Subject: Duke Energy Carolinas, LLC (Duke)
McGuire Nuclear Station, Unit 1
Docket No. 50-369
Relief Request Serial #09-MN-002
Response to Request for Additional Information

Relief Request 09-MN-002

Response to NRC Request for Additional Information

Figure 2 (Example of Repair/Replacement Conforming to Proposed Alternative)

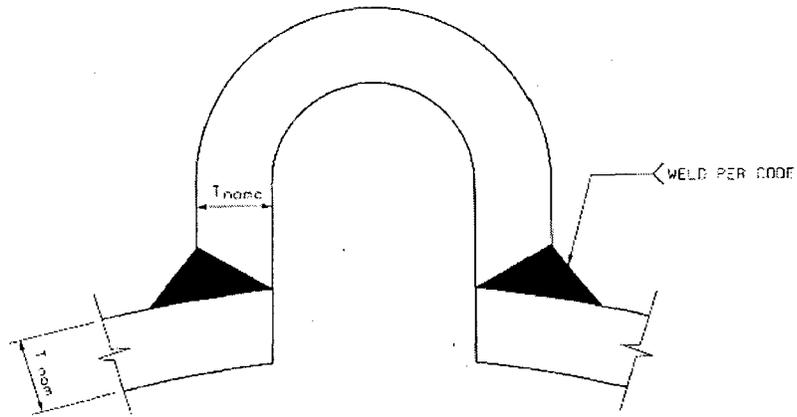
8. *For the following hypothetical scenarios, please briefly describe the anticipated repair design, structural integrity analysis, the repair procedure, the NDE of the modification and the pressure test. Please include sketches if appropriate.*

a. *Pitting over a 10 square inch area without through-wall leakage.*

Response: A defective area of 10 square inches that results from pitting would be encapsulated in accordance with our proposal. The design of the encapsulation shall be in accordance with all applicable requirements of the component construction code. The encapsulation would be attached to the component using a full-penetration weld to the outside surface of the component and would conform to the requirements of the construction code. Applicable non-destructive examination required by the construction code would be performed on the full penetration weld. Pressure testing would be performed as described in our response to question 7.

Figure 1 (Example of Code-Compliant Repair)

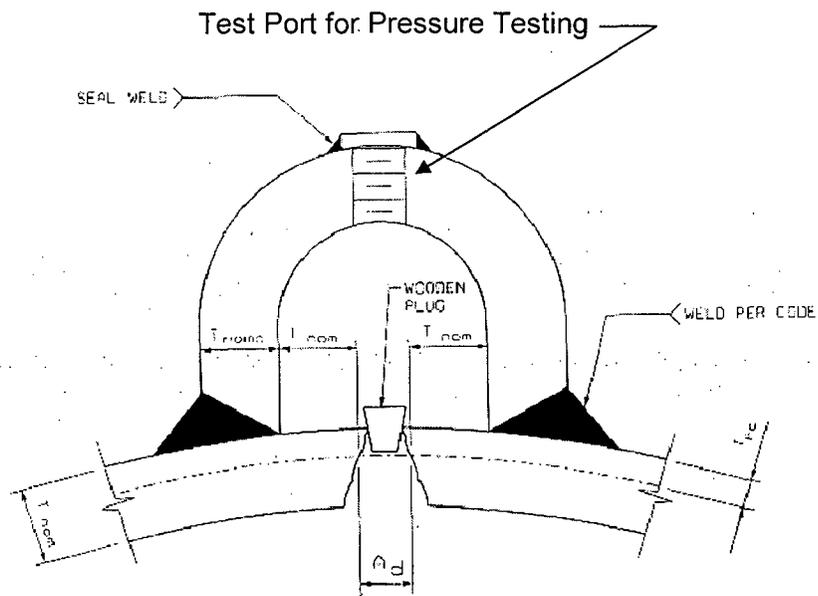
A code compliant repair can be accomplished by welding a coupling or pipe cap to the exterior surface of the component, provided the defective portion of the component wall has been removed and is not relied on for pressure boundary integrity. For this type of repair, a relief request is not required. Figure 1 shows an example of a code compliant repair of this nature.

If the defective portion of the component wall has not been removed prior to welding a coupling or pipe cap over the defective area, Duke believes that the requirement of IWA-4400 has not been met and that the repair/replacement activity is not considered to be in compliance with the requirements of the ASME Code, Section XI. Figure 2 shows an example of this type of repair/replacement activity that complies with the proposed alternative in 5.1 and 5.3.c of our request. For the proposed alternative shown in Figure 2, there is actually more material remaining in the component wall within the welded encapsulation than is provided by the code compliant repair shown in Figure 1. Please note that Duke plans to install protective coatings material into the

encapsulation following completion of the repair/replacement activity, system leakage test and VT-2 visual examination, provided the wooden plug (or other temporary seal) continues to seal the defective area sufficiently to allow for installation of the protective coatings material. Installation of protective coatings will eliminate concern that the interior surfaces of the encapsulation and its attachment weld will be subject to conditions that could cause continued corrosion. For these reasons, Duke believes that the proposed alternative provides an acceptable level of quality and safety as that afforded by the code compliant repair/replacement activity shown in Figure 1.
